ADDENDUM NO. 5

TO: PLANS AND SPECIFICATIONS FOR STATE OF MISSOURI

Renovate Mechanical / Electrical / Life-Safety / State Office Building
Jefferson State Office Building
205 Jefferson Street
Jefferson City, MO 65101
PROJECT NO. O1911-01

SHEET NUMBER:
M3.3
98 OF 244 SHEETS

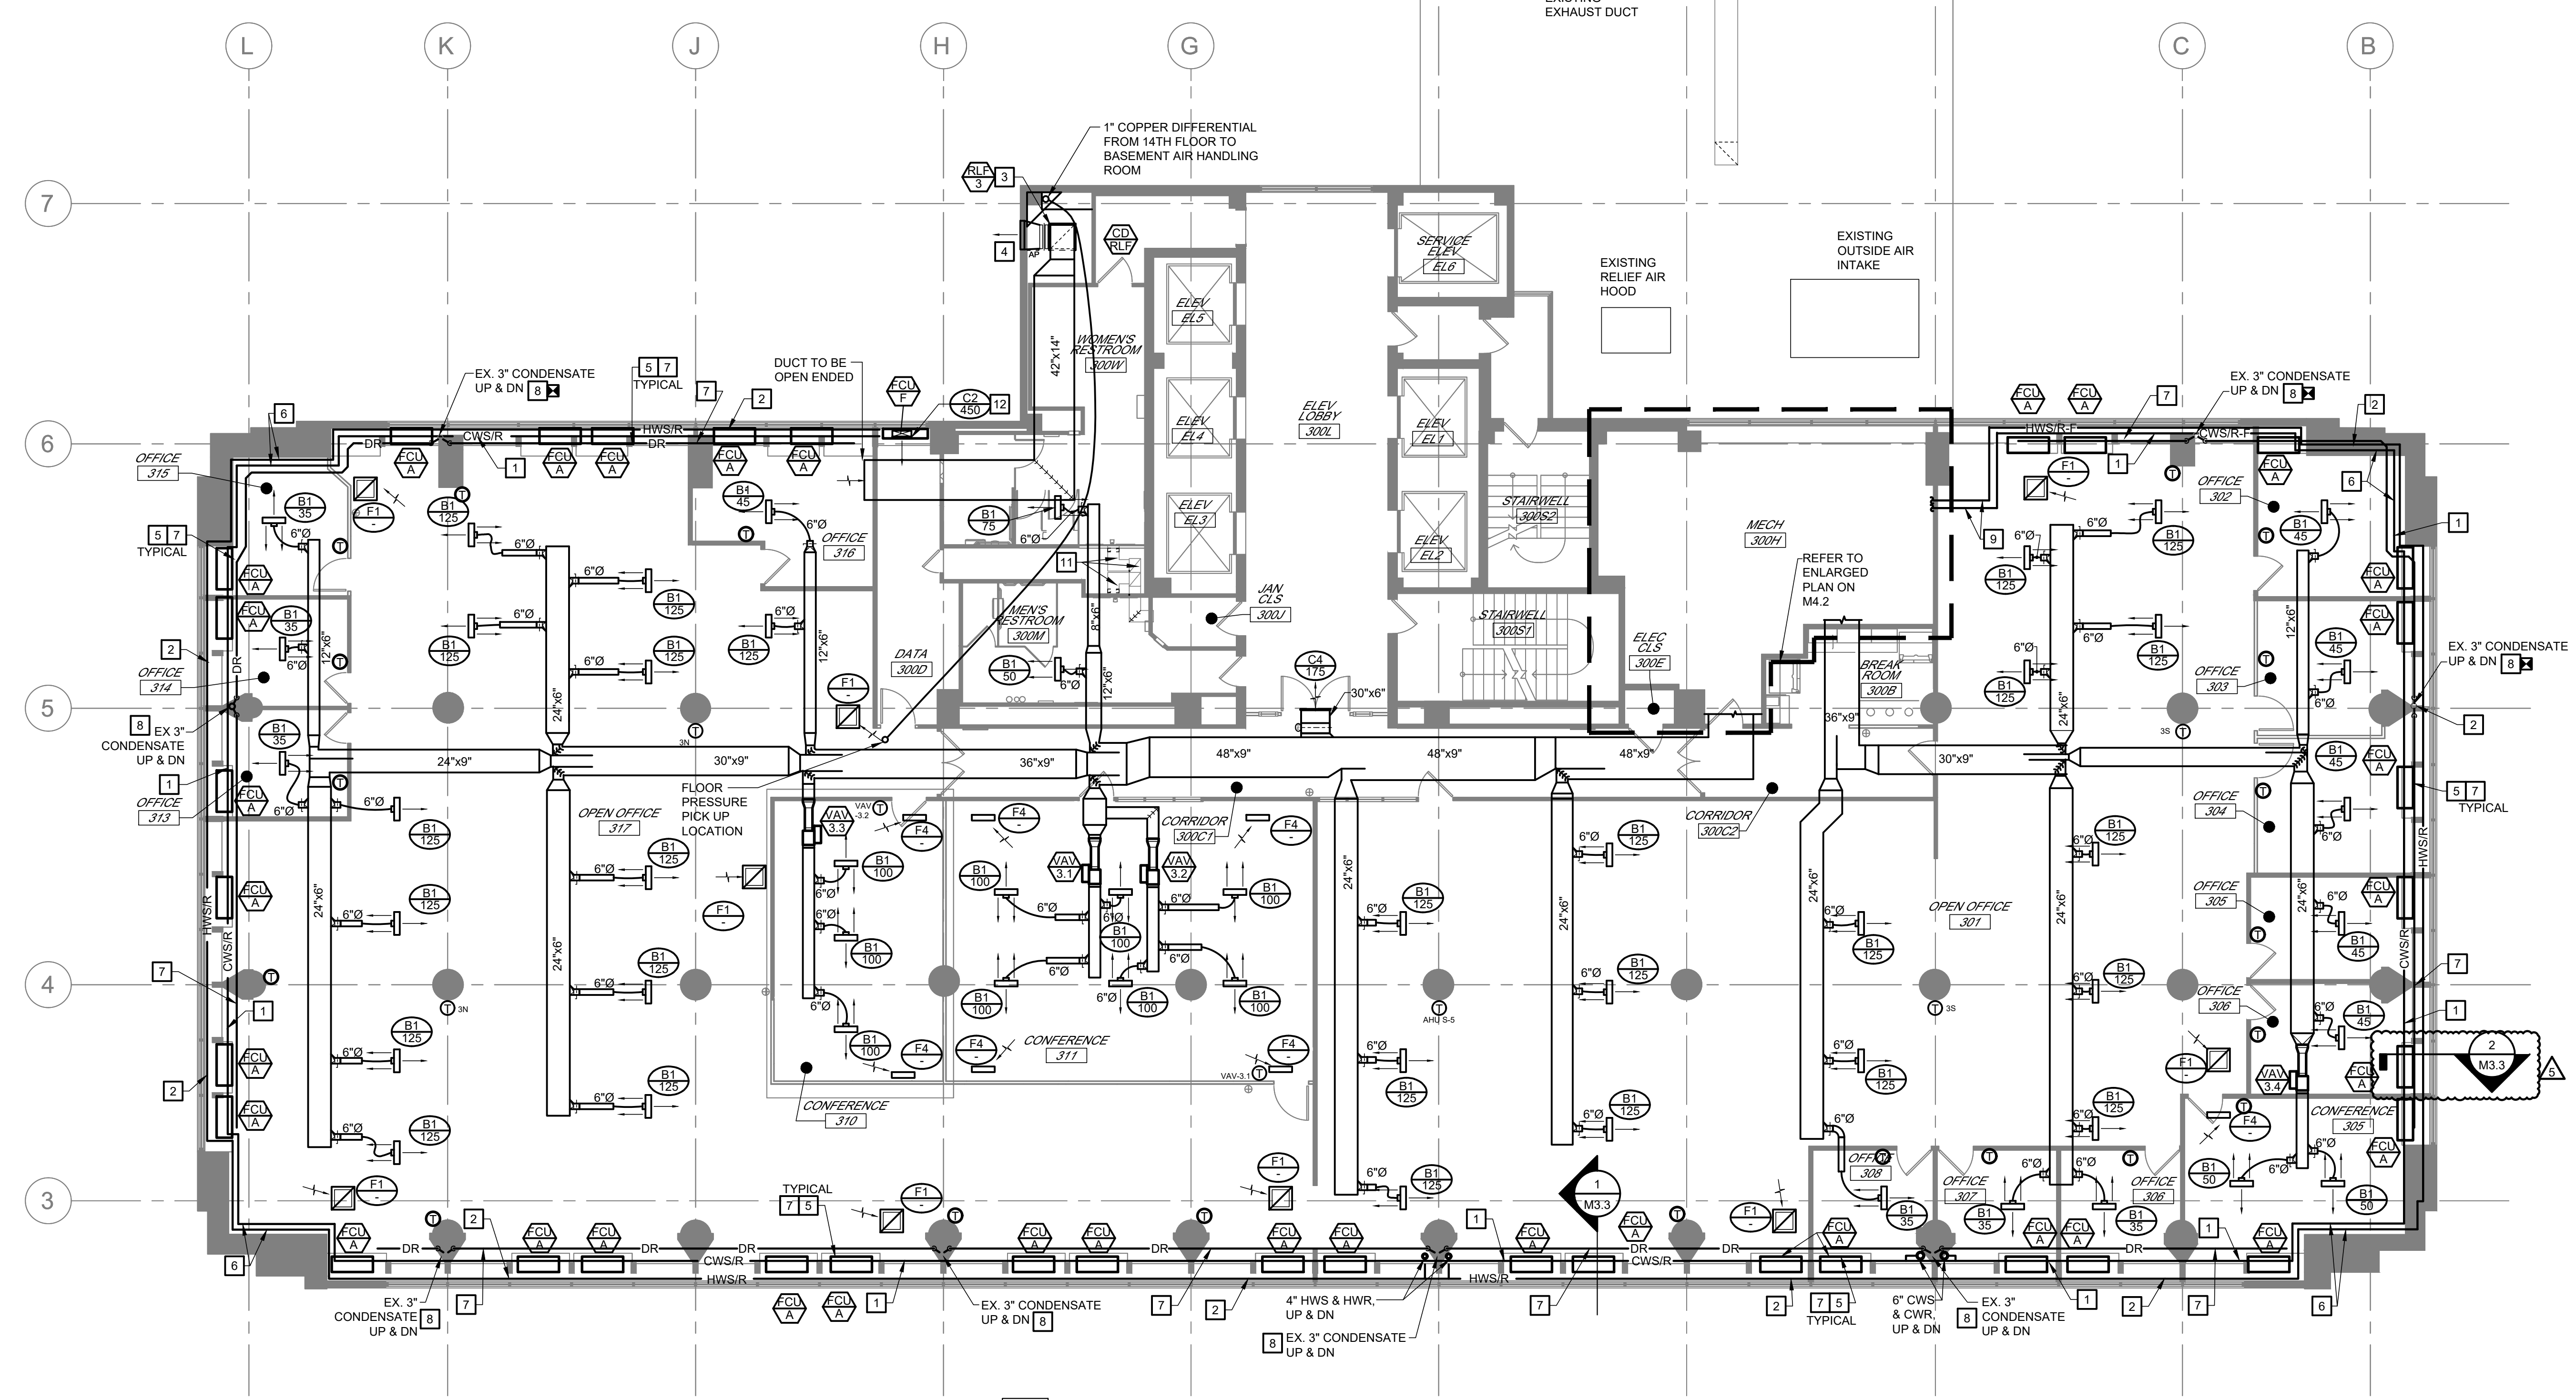
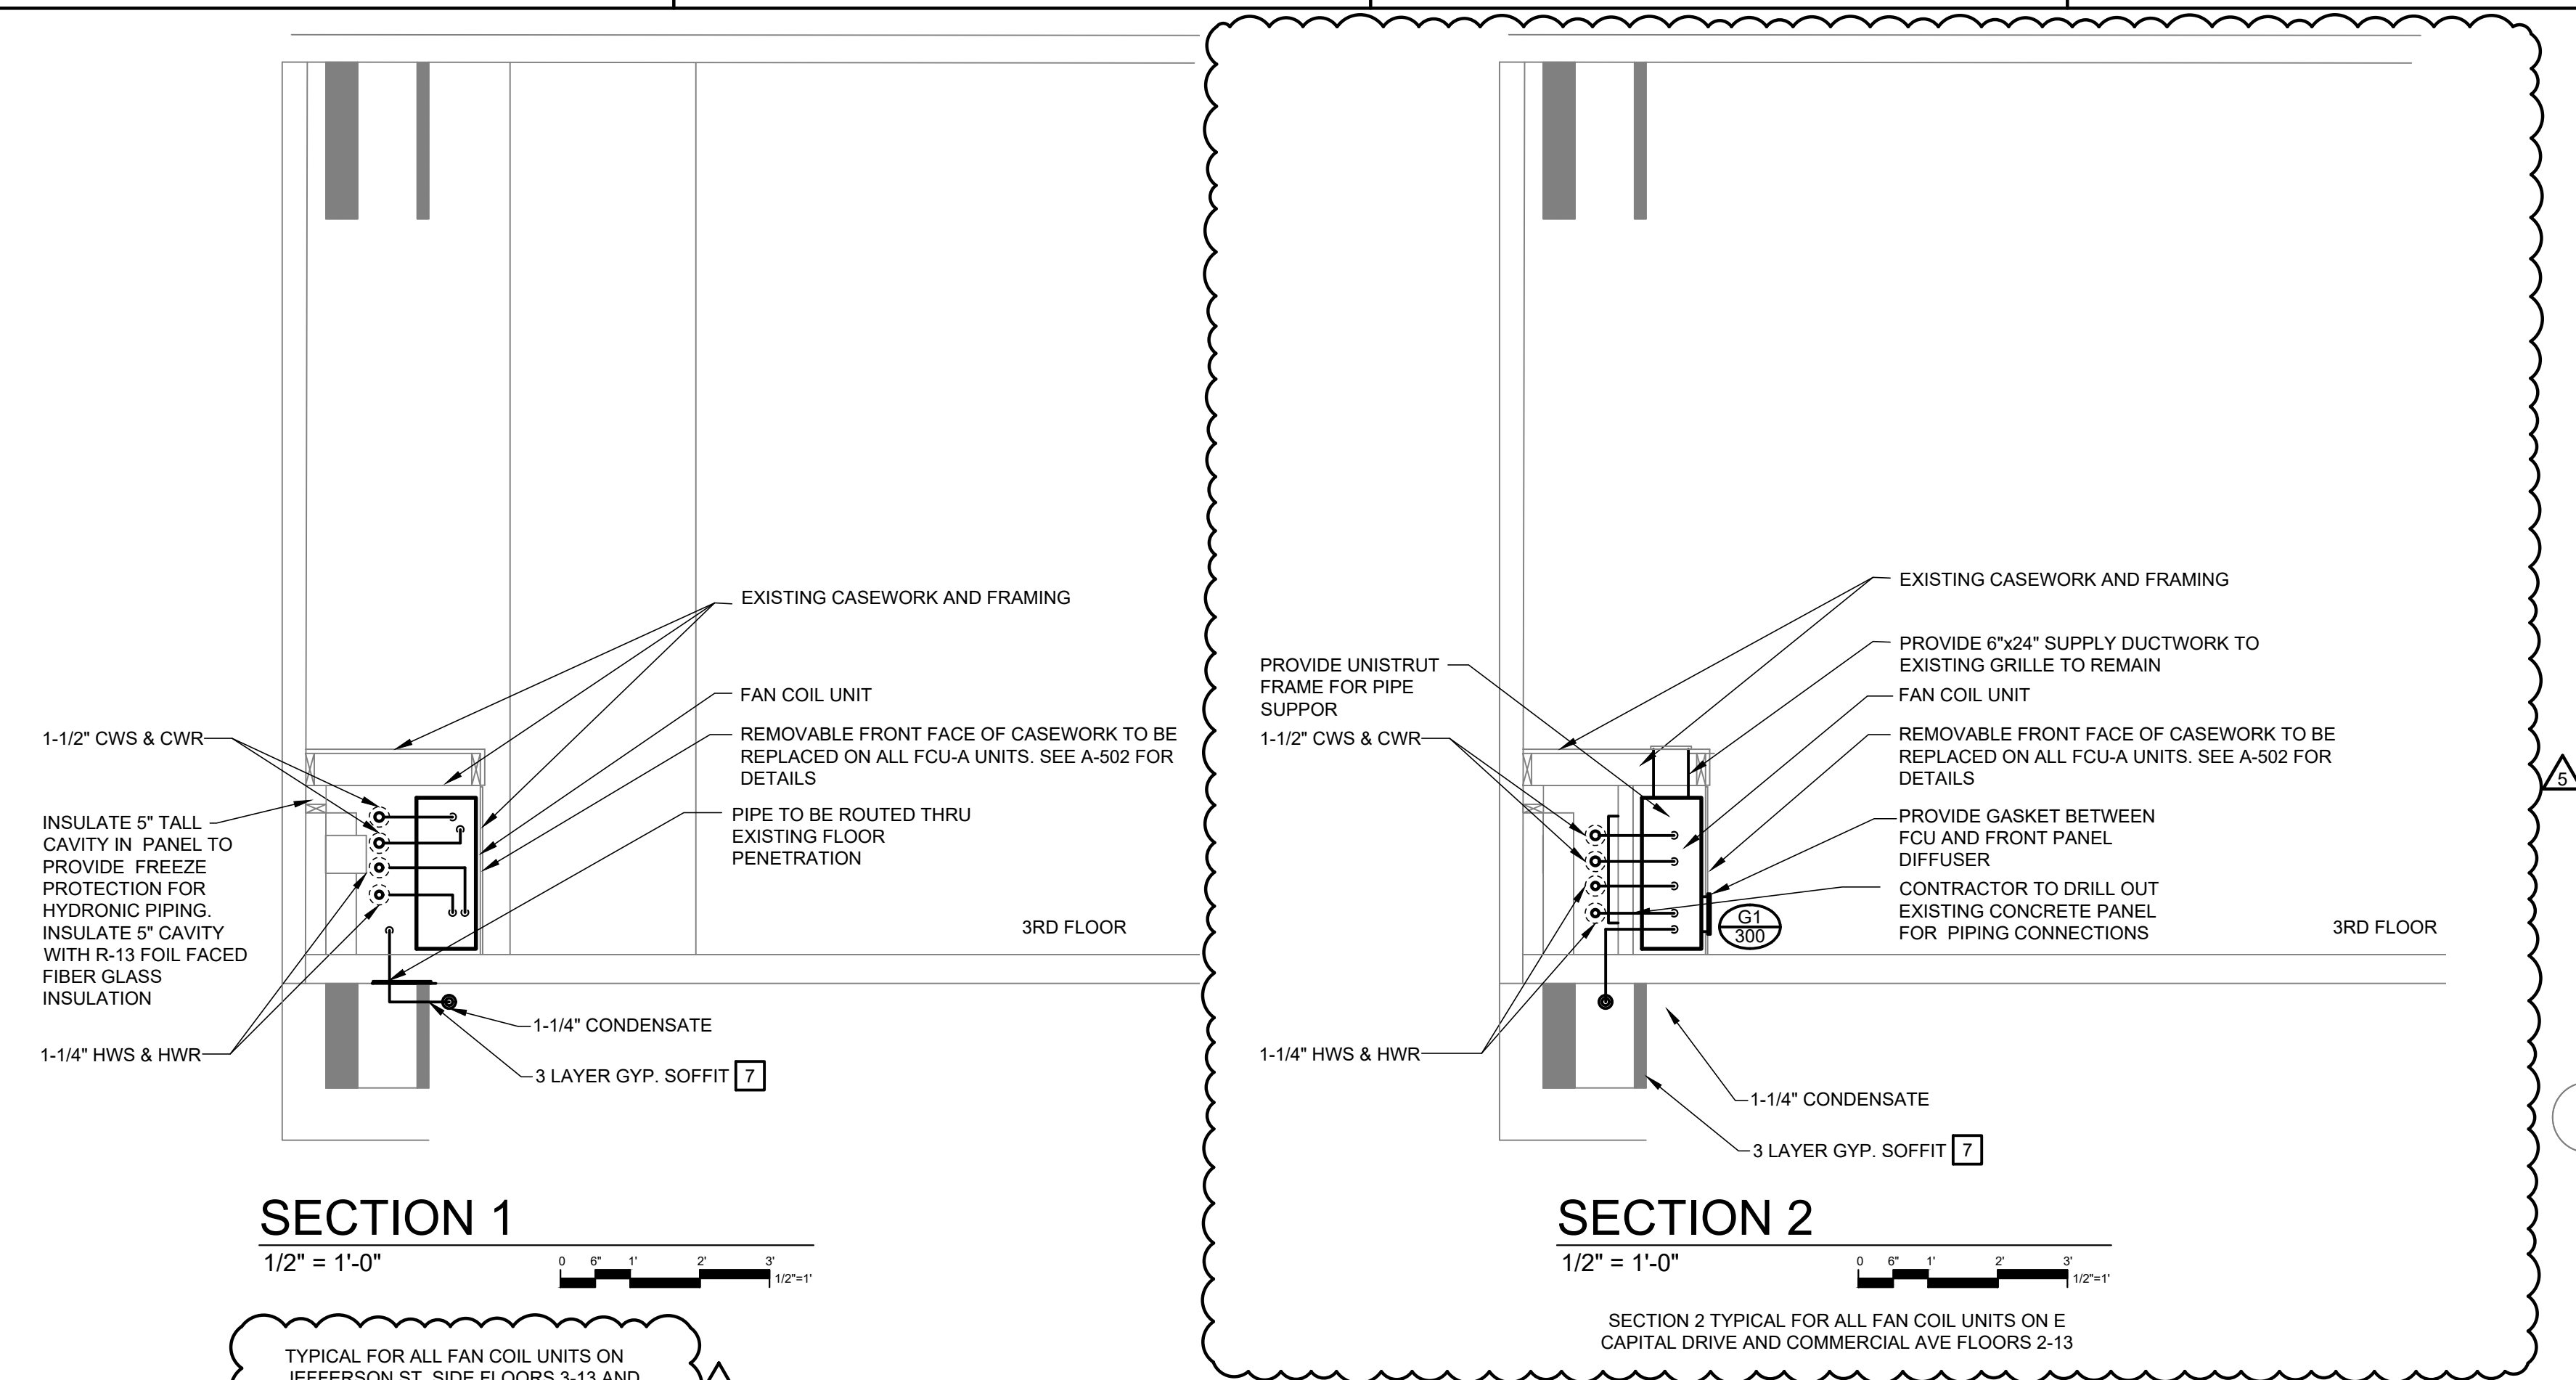
12. Drawing M3.1
- a. ADD - Condensate Piping.
13. Drawing M3.2
- a. ADD - FCU Section.
 - b. Adjust Piping.
14. Drawing M3.3
- a. ADD - FCU Section.
15. Drawing M3.12
